RECAPP Facility Evaluation Report

Edmonton School District No. 7

Greenfield School

Evaluation Details

CRACKED MASONRY - ROOM 11

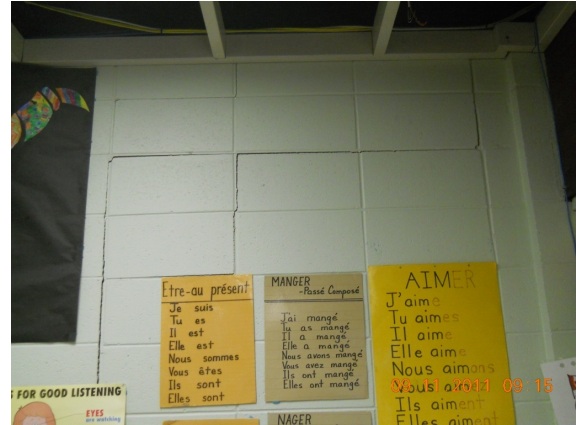
Due to shifting of the structure there are numerous locations where mortar joints in the concrete block walls have opened. This is unsightly and site personnel indicate that in some locations the voids have extend entirely through the wall. There is evidence that patch repairs are done regularly and this practice should be continued and combined with possible major local structural upgrades if the movement becomes excessive.

Patch and paint portions of block walls exhibiting the worst cracks.
